Connah's Quay Low Carbon Power

Environmental Statement Volume III
Figure 6-6: Indicative Location of Design Changes

Document Reference: EN010166/APP/6.3

Revision 00

Indicative Location of Design Changes
Sheet 1 of 3

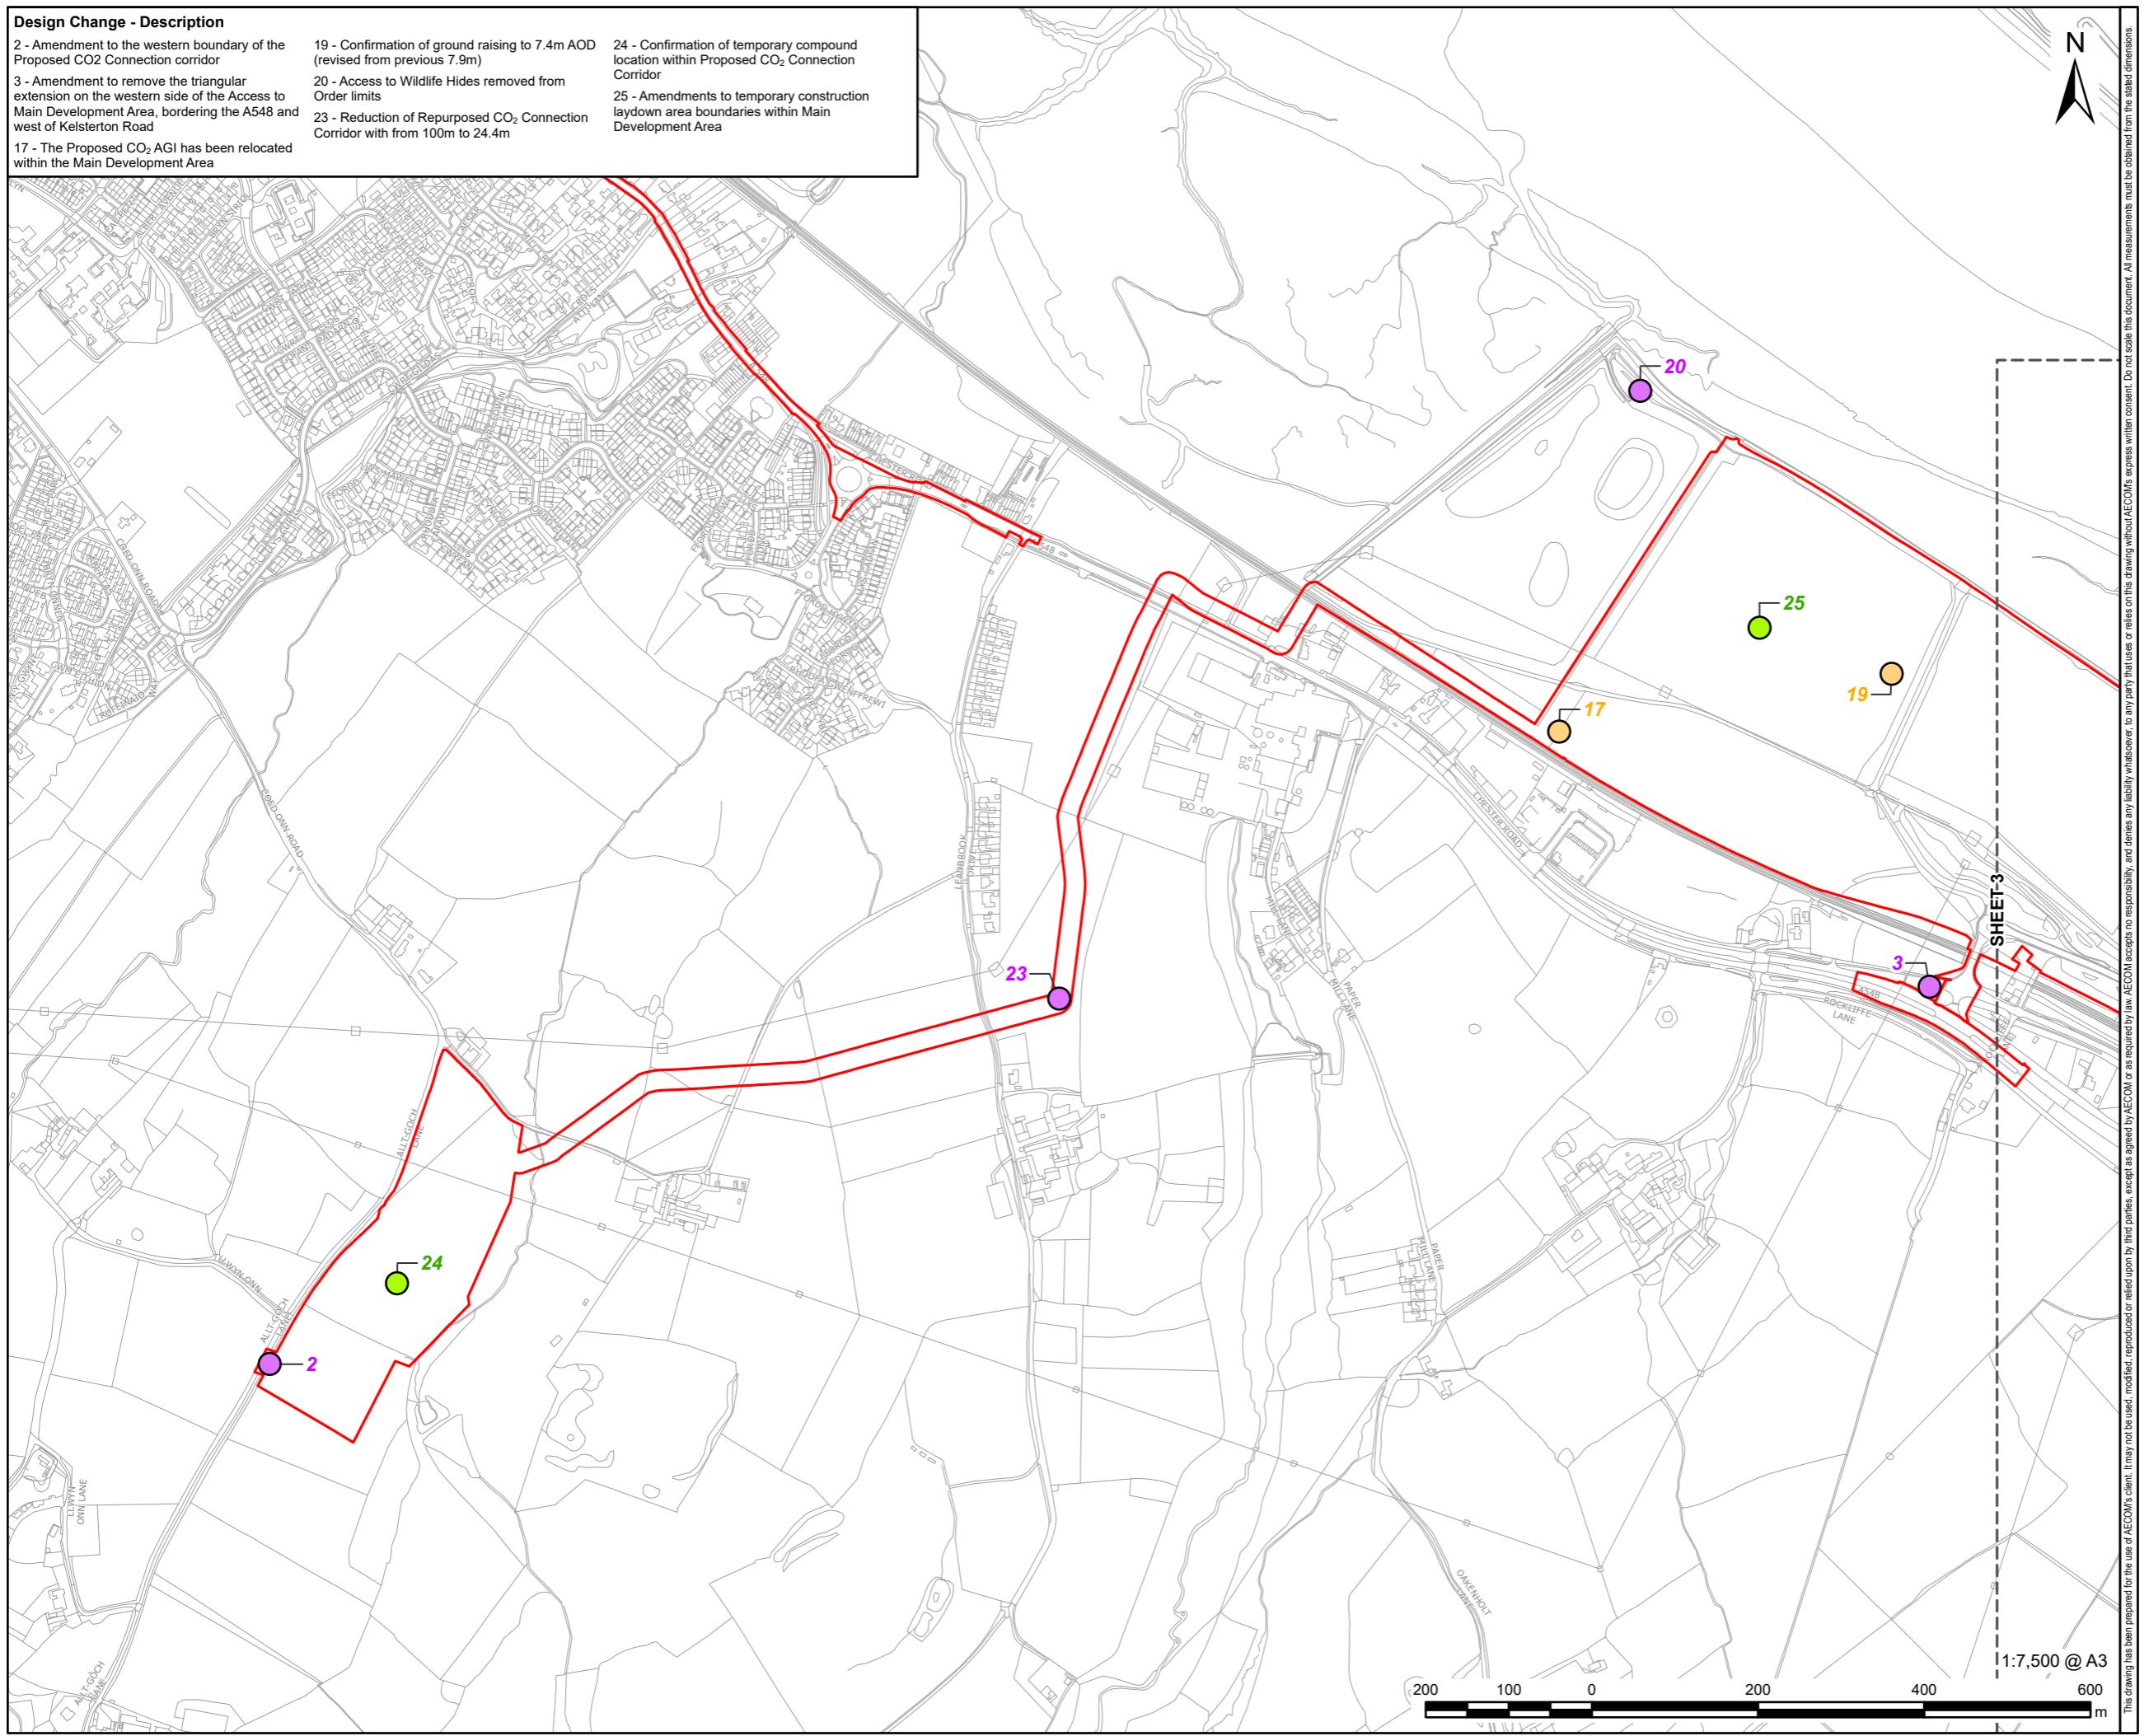
Design Change - Description

1 - Inclusion of for potential temporary works to facilitate transport of AILs within the Order limits

26 - Removal of AIL vessel mooring, offloading, and temporary storage areas at Ports of Mostyn and Ellesmere from the Order limits

27 - Works to widen access/egress across the level crossing at Port of Mostyn
